Technical Service Bulletin

Cobra Motorcycle Mfg.

TSB0504: 2004 King & CM50 water pump drive belt & pulley alignment & inspection.

April 2, 2004

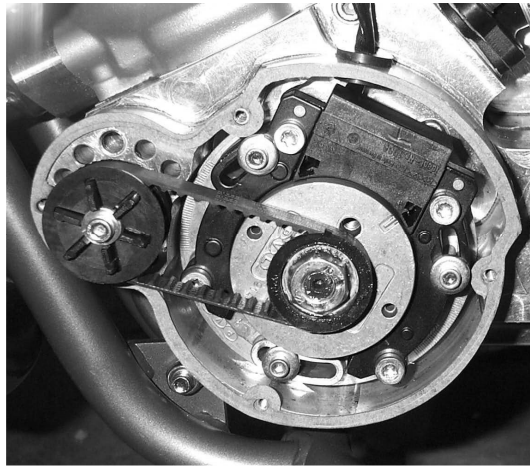
It is important to inspect three things on the water pump drive pulley and belt.

1. That the belt and pulleys are in proper alignment and that the belt is not rubbing on flywheel or edges of the pulleys
2. That the pulleys are not cracked
3. That the water pump impeller pulley fastener is tight and has adequate high strength thread lock agent applied.

Below is the proper orientation of the water pump drive pulley, cover, and spacers.
